City of Albuquerque

DESIGN HYDROLOGY SECTION
123 Central NW, Albuquerque, NM 87102
(505) 766-7644

RE: REVISED DRAINAGE PLAN FOR ZEPHYR CENTER
RECEIVED FEBRUARY 7, 1986 (L-22/D42)

RE: DRAINAGE PLAN FOR ZEPHYR CENTER
RECEIVED NOVEMBER 22, 1985 (L-22/D42)

SECTION B-B

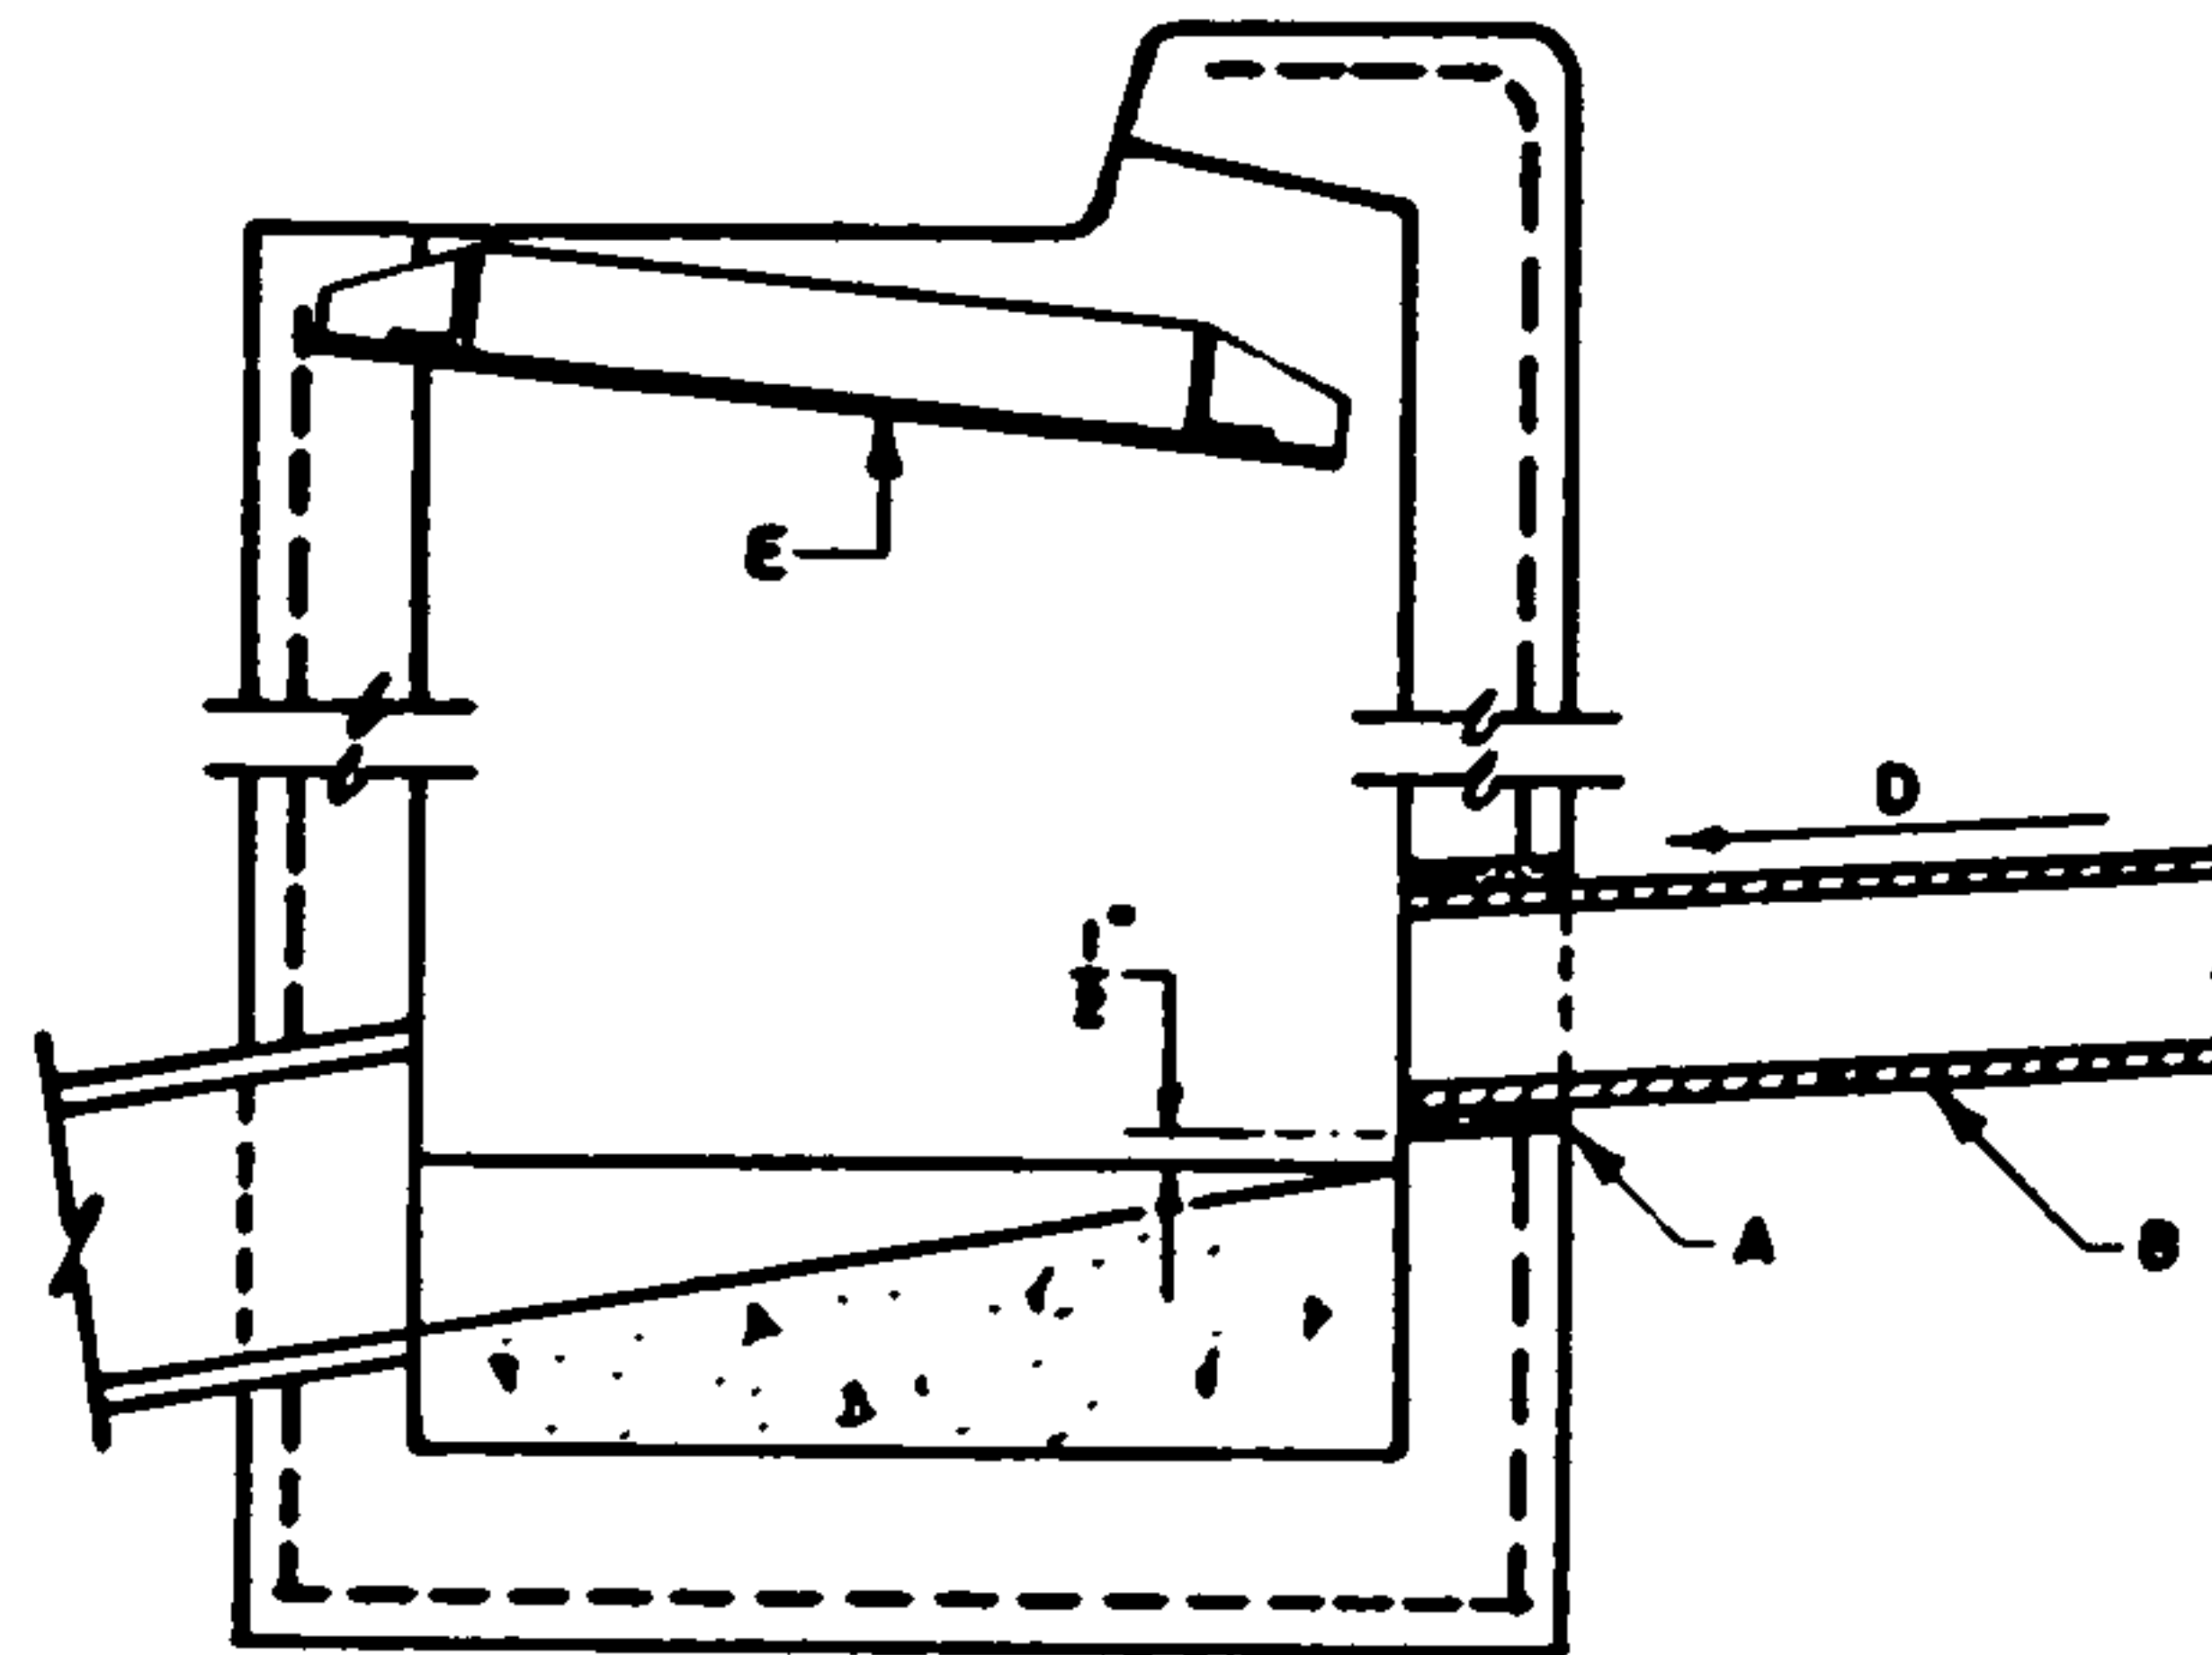
The maximum size pipe allowed for a drain line connection to an existing storm inlet is 12-inches (See DWG 2237 enclosed). This limitation, unfortunately, will negate the drainage plan which you have presented.

1. 24" diameter storm drain was based on a miscalculation. The correct size storm drain outlet to the existing Central Ave. inlet is actually 12" a minimum slope of 0.0200'/'.
 - Keyed note #13: *"install 36 lf 12" dia. PVC storm drain from new storm drain inlet to back of existing storm drain inlet within Central Blvd. Minimum slope = 2.0%. Contractor to field verify existing storm drain inlet flowline to and notify engineer if minimum slope cannot be met.*
 - Invert modified to accommodate minimum 2.0% slope.
 - Supplemental Calculations revised (highlighted in blue) as required.
